3.0 Draft EIR Errata

3.2 ERRATA

Table 3.0-1, Corrections to the Draft EIR (pages 3.0-4 through 3.0-8), contains corrections and clarifications that are made to the text of the Draft EIR.

Revised Figure 4.7-1
 Site Habitats and Noise Berm Location
 M&T CHICO RANCH MINE
 BUTTE COUNTY, CALIFORNIA

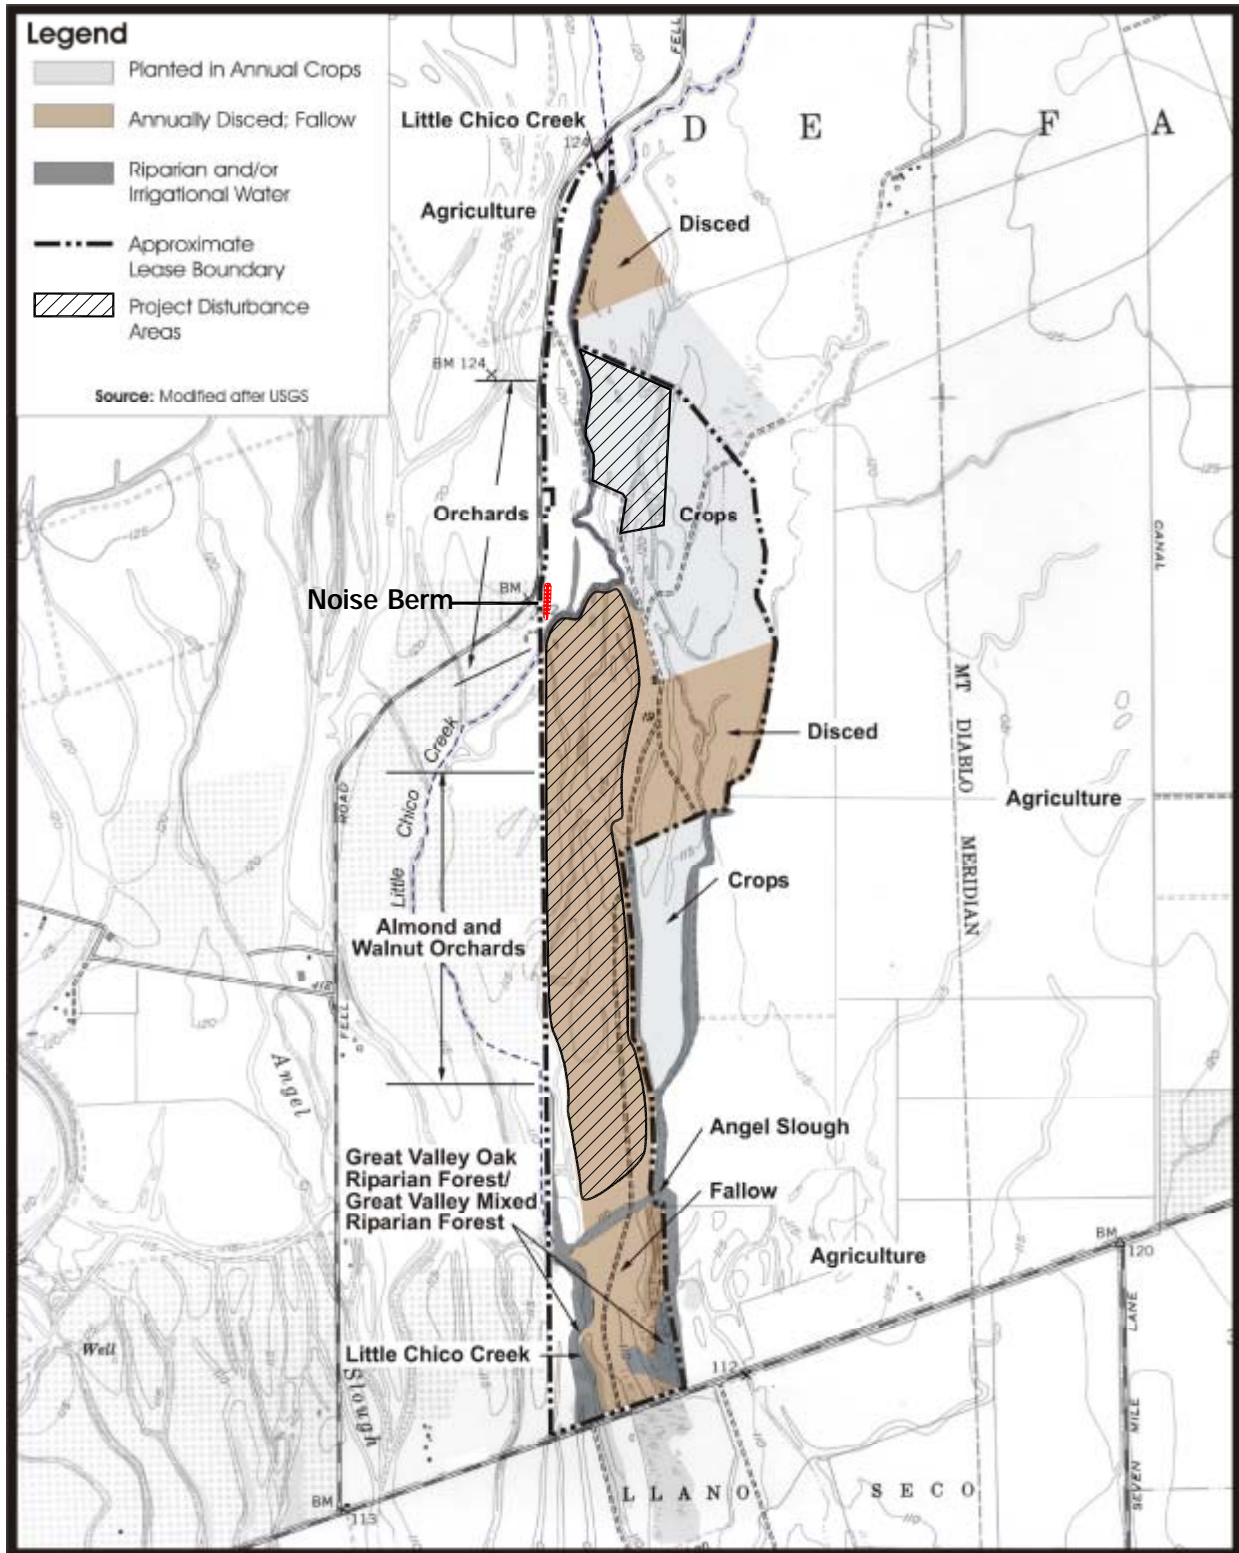
Draft EIR Figure 4.7-1, Site Habitats, has also been revised and is now entitled Revised Site Habitats and Noise Berm Location. Some commenters mentioned difficulty in interpreting the black and white version of this figure. The overlay of project disturbances was also problematic. The figure is reproduced in color here, the proposed noise berm has been added, and the project disturbance overlay has been made more readable.
